UNITED STATES PATENT AND TRADEMARK OFFICE

APPLICATION NO.	FILING DATE	FIRST NAMED INVENTOR	ATTORNEY DOCKET NO.	CONFIRMATION NO.
10/824,883	04/14/2004	Man Keung Tse	039236-026000	7295
22204	7590	03/21/2006	EXAMINER	
NIXON PEABODY, LLP 401 9TH STREET, NW SUITE 900 WASHINGTON, DC 20004-2128			BROUSSARD, COREY M	
			ART UNIT	PAPER NUMBER
			2835

Office Action Summary

DETAILED ACTION

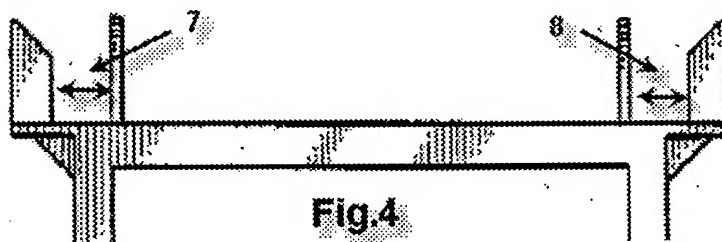
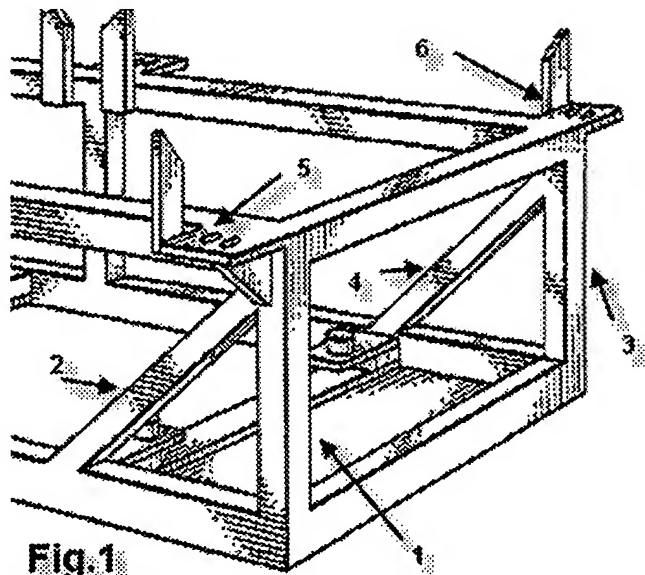
Stewart lacks vertical members extending to corresponding fins extending away from the module in different directions and defining a gap. Tate teaches a power module support (with labeled elements shown below), having a first vertical piece (1) extending from the base to a first fin (5) that extends out from the base away from the module (the module would be supported inside of the frame) in a first direction, and having a second vertical piece (3) extending from the base to a second fin (6) that extends out from the base away from the module in a second direction, the power module plugging into the stand defining a first gap (7) along an edge of the first fin that is adjacent to the first side of the power module and defining a second gap (8) along an edge of the second fin that is adjacent to the second side of the power module, allowing vertical heat dissipation generated by the power module with air flow vertically through the first and second gaps and along respective substantially vertical surfaces of said power module. It would have been obvious to a person of ordinary skill in the electronic art to combine the power supply system of Stewart with the conventional power supply support of Tate for the benefit of a lightweight support frame having large windows for cooling air.

10. With respect to claim 2 as best as it can be understood, Tate teaches wherein the stand comprises a third vertical piece (2) extending from the base to the first fin (5), a further vertical piece (4) extending from the base to the second fin (6), the first and third vertical pieces forming a first vanes-shaped configuration with an opening between the first and third vertical pieces, the second and fourth vertical pieces forming a second vanes-shaped configuration with an opening between the second and fourth vertical pieces.

16. With respect to claim 14 as best as it can be understood, Tate teaches wherein the stand comprises a third vertical piece (2) extending from the base to the first fin (5), a further vertical piece (4) extending from the base to the second fin (6), the first and third vertical pieces forming a first vanes-shaped configuration with an opening between the first and third vertical pieces, the second and fourth vertical pieces forming a second vanes-shaped configuration with an opening between the second and fourth vertical pieces.
